CEC Data Request Response No. 1

Potentia-Viridi Battery Energy Storage Project

DECEMBER 2024

Exhibit TRANS-1. Re-Designed Emergency Access Road off of Patterson Pass Road

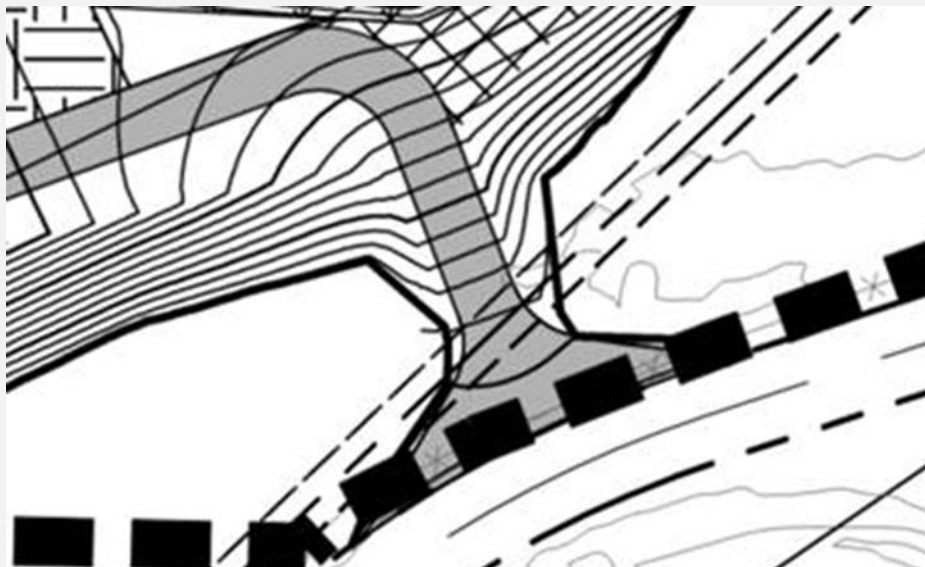
DR BIO-3: Provide a drawing, description, and assessment of the safety and adequacy of the project’s driveway on Patterson Pass Road. The intersection as depicted on Figure 2, Appendix 3.12, shows a narrow steep driveway intersecting Patterson Pass Road with limited acceleration or deceleration space for heavy vehicles entering and exiting the facility.

RESPONSE: After further evaluation of the project’s driveway on Patterson Pass Road, it was determined that this entrance would only be used for emergency vehicle access for both project construction and operational activities. The driveway apron was expanded to allow vehicles space to decelerate off the main road and to provide additional visibility for exiting vehicles to enter onto Patterson Pass Road. A sight distance analysis was conducted at the southern project driveway and is provided in Section 7.2 of the revised Transportation Analysis (Attachment 4).

As shown in the exhibit below, the driveway entrance at Patterson Pass Road has been re-designed according to the Engineering Design Guidelines for Unincorporated Alameda County to provide 100 feet of straight driveway perpendicular to the centerline of Patterson Pass Road. The grade has been adjusted to provide a maximum 6% grade for 50 feet from the road edge. Entry to the site will be through the gate at the entry to the BESS yard and the gate adjacent to the roadway has been removed.

Figure ALT-1 Alternatives

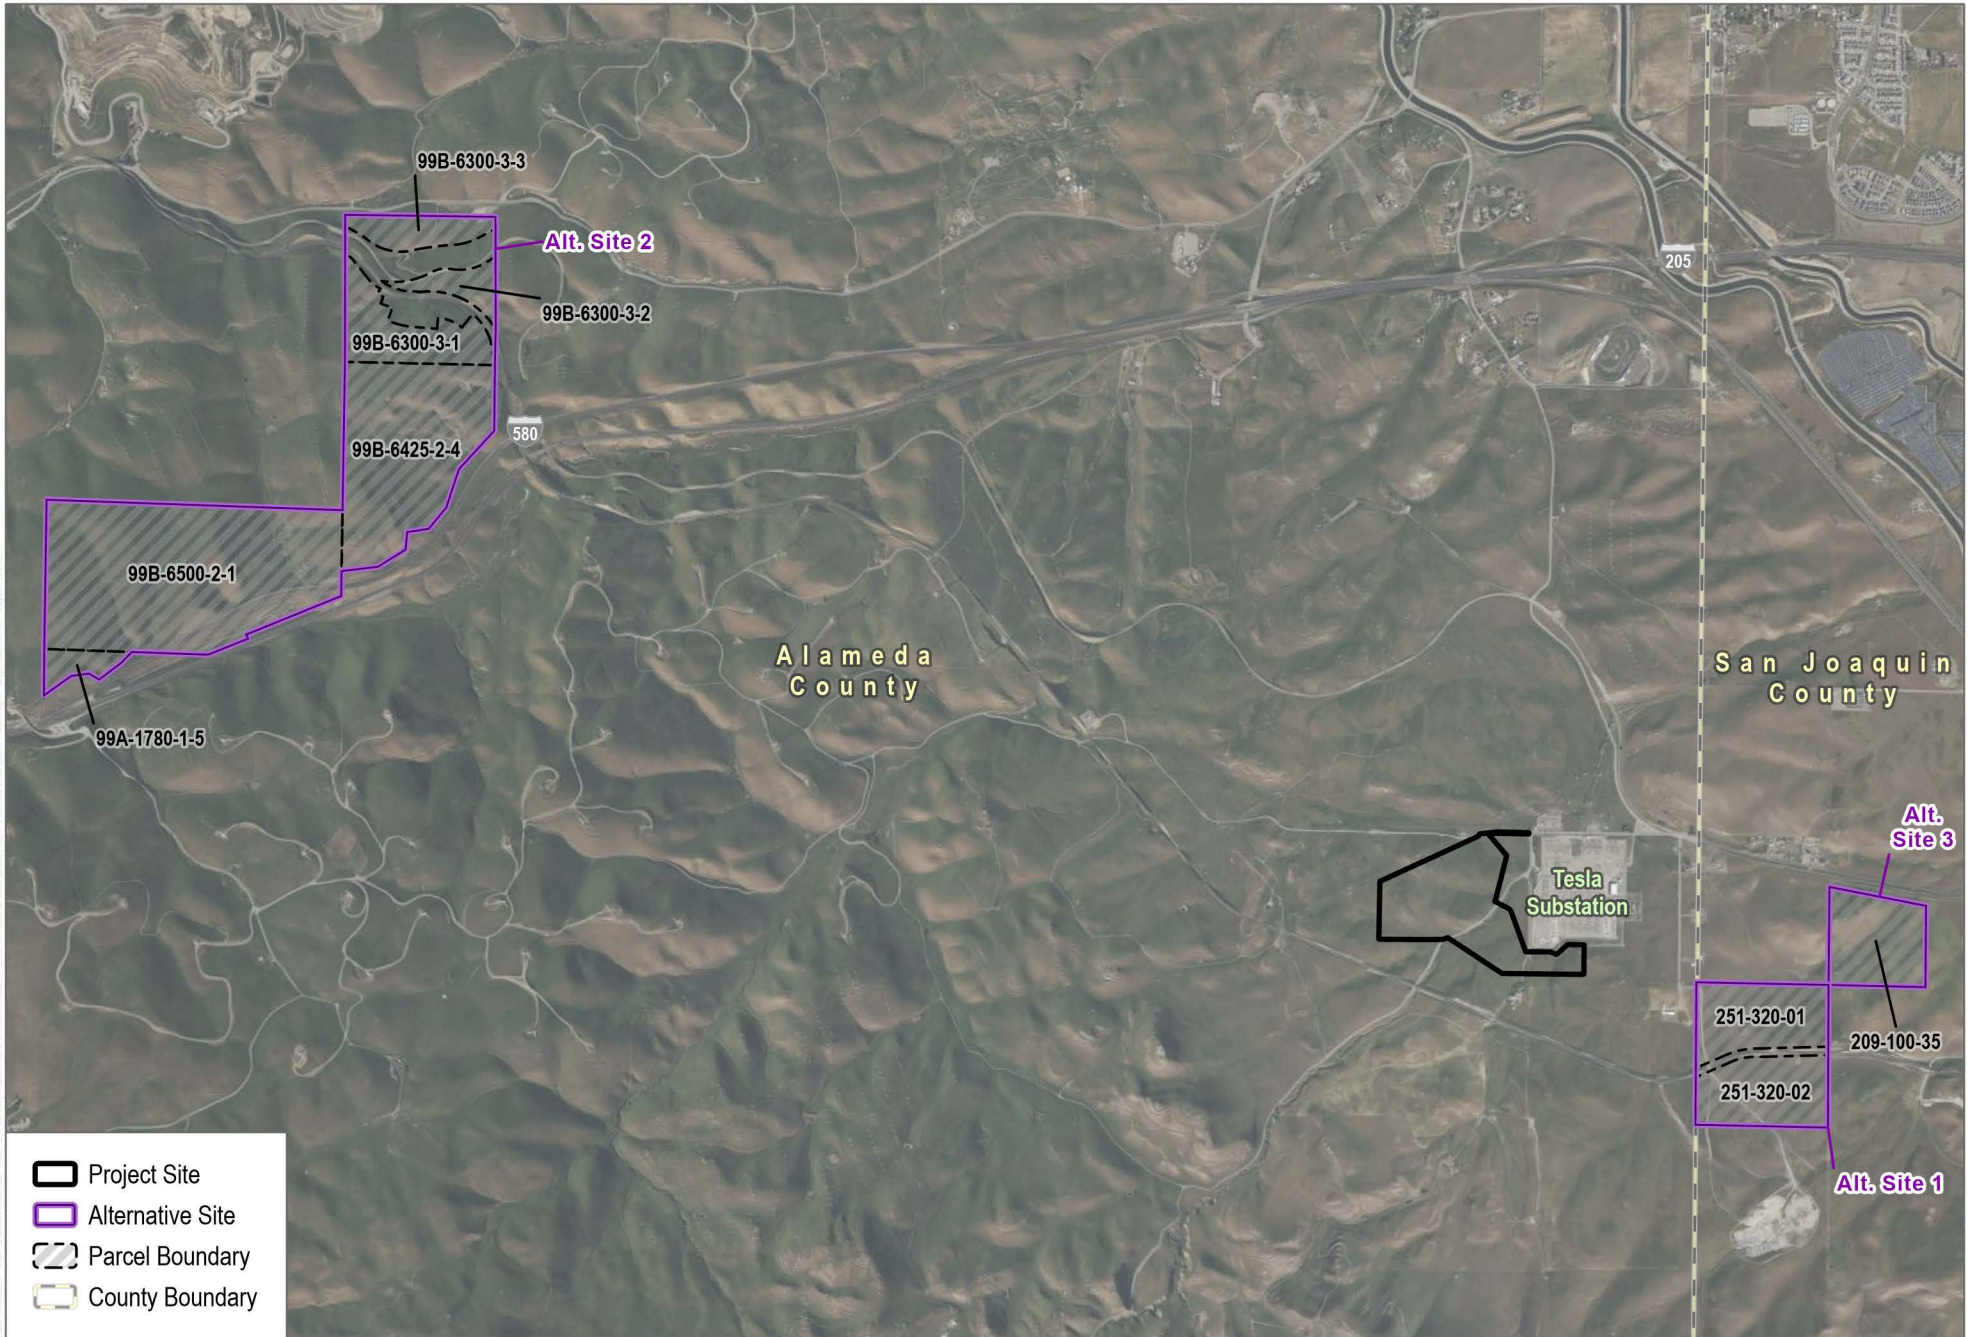
DR ALT-1. Data is required that evaluates the comparative environmental merits of alternative sites to the proposed project site. Please provide assessor’s parcel numbers and large-scale, zoomed in maps showing the locations of the alternative sites that were considered and rejected. Please provide additional data on these sites that was collected prior to submittal of the application (i.e., specific information from a preliminary site assessment or constraints analysis).

RESPONSE: As detailed in Table Alt-1, three alternative locations were considered by Levy Alameda LLC for the Potentia–Viridi Battery Energy Storage System (BESS) Project (Figure ALT-1, Alternatives). Although discussions and initial agreements were initiated with the various landowners of the alternative sites, no additional detailed site assessments or constraints analyses were performed because none of the alternative sites had viable generation tie-line (gen-tie line) routes to Pacific Gas & Electric’s (PG&E) Tesla Substation. As such, all three alternative sites were considered but rejected.

Revised Figure 3.4-1 Surface Geology

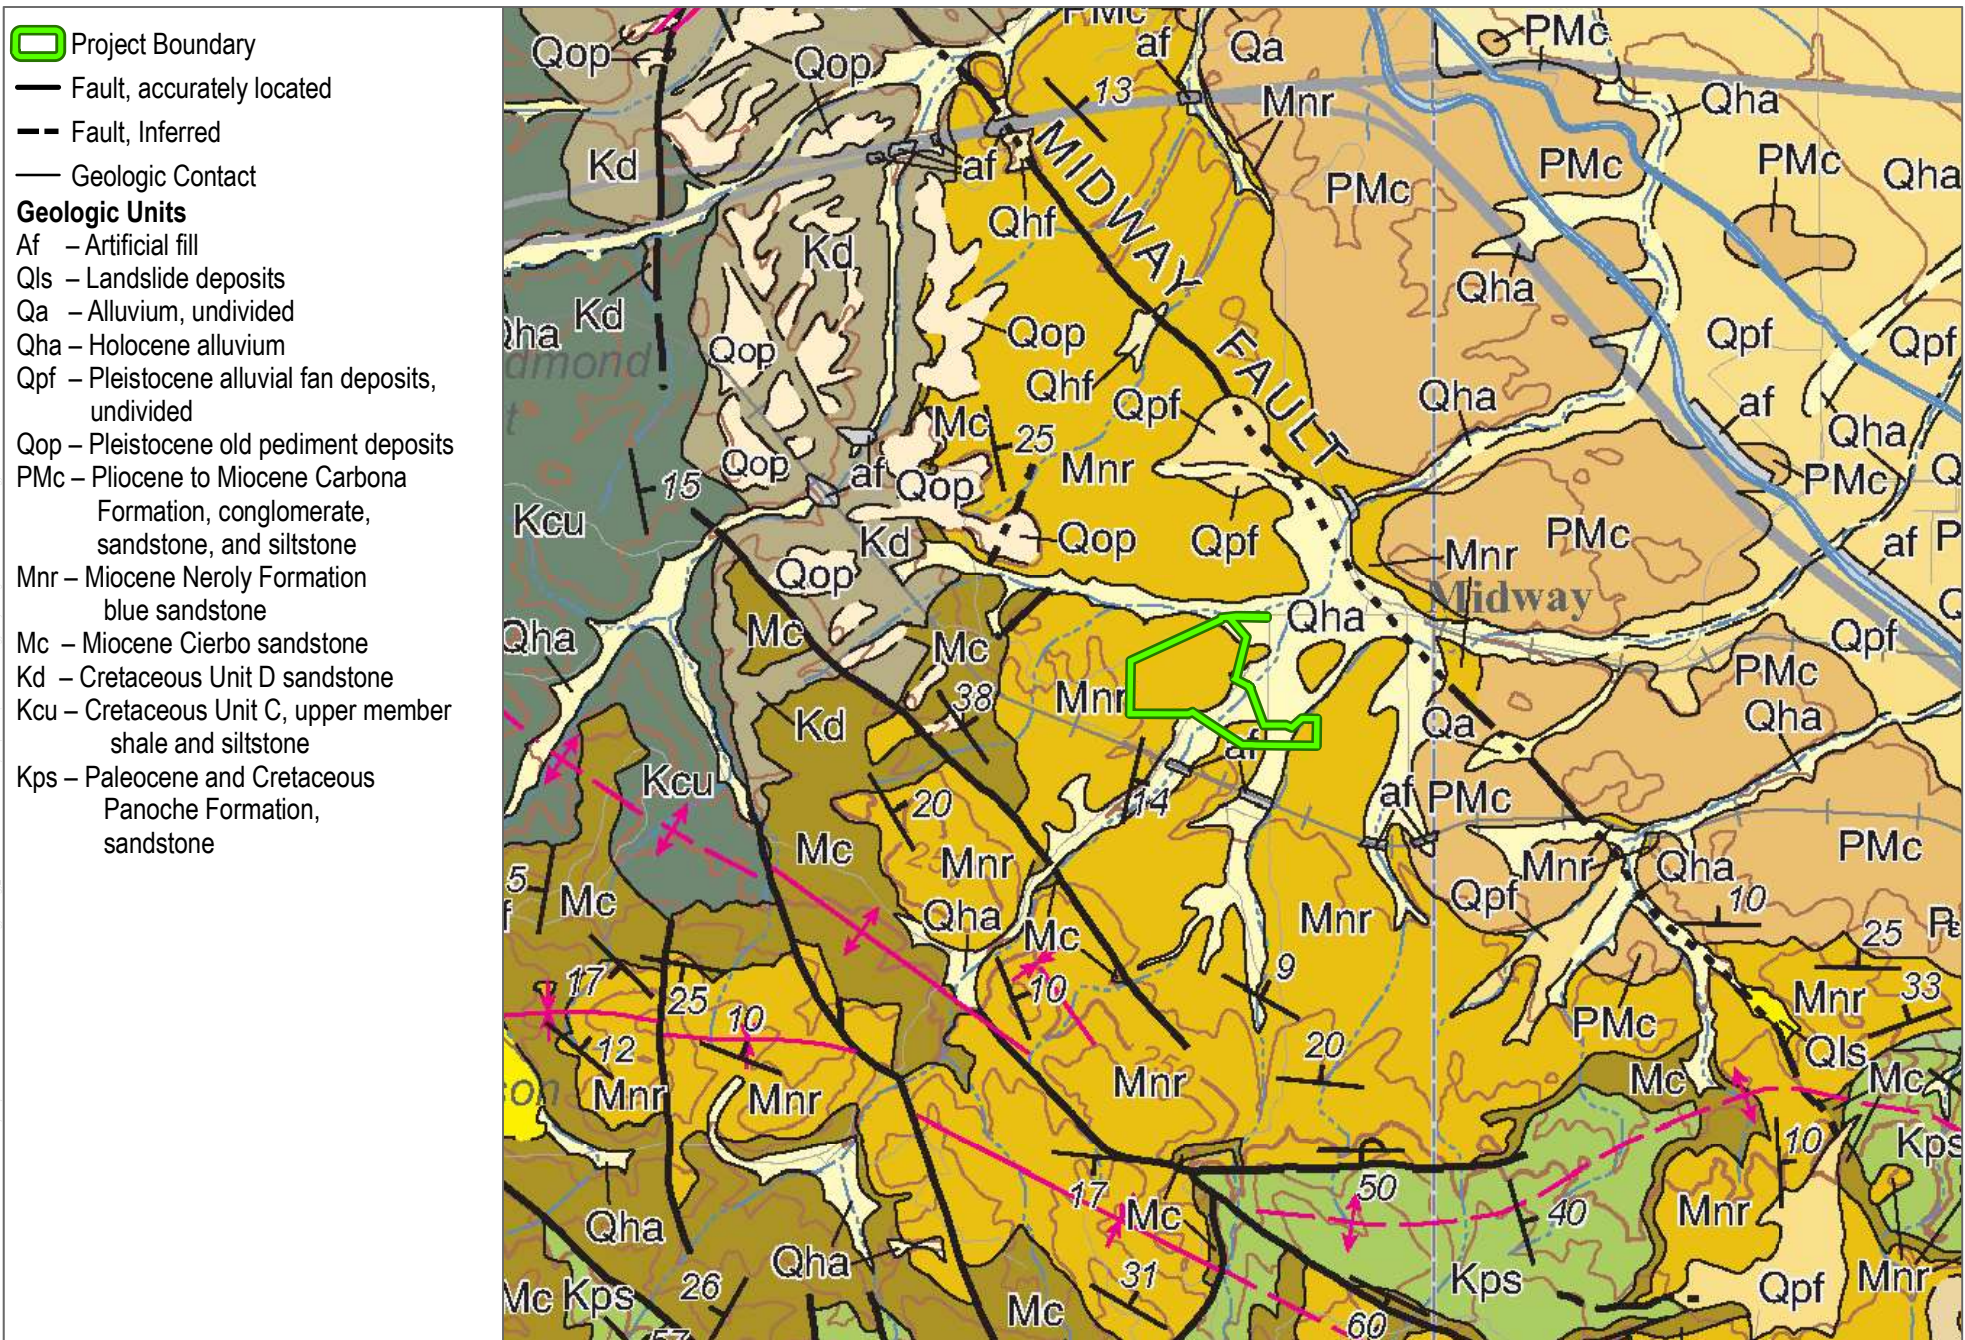
DR GEO-1. Please revise Figure 3.4-1 using a more current reference as a basemap to depict the surface geology. CEC staff suggests utilizing “Deattre, M.P. et. al 2023. Geologic and Geophysical Maps of the Stockton 30’ x 60’ Quadrangle, California Joint venture between California Department of Conservation, U.S.G.S., and the Coast Range Geologic Mapping Institute” available at: https://www.conservation.ca.gov/cgs/Documents/Publications/Regional-Geologic-Maps/RGM_005/RGM_005_Stockton_100k_2023_Plate1of1_a11y.pdf.

RESPONSE: Figure 3.4-1 has been revised in response to the DR GEO-1 comment. Revised Figure 3.4-1, Surface Geology, is included below.
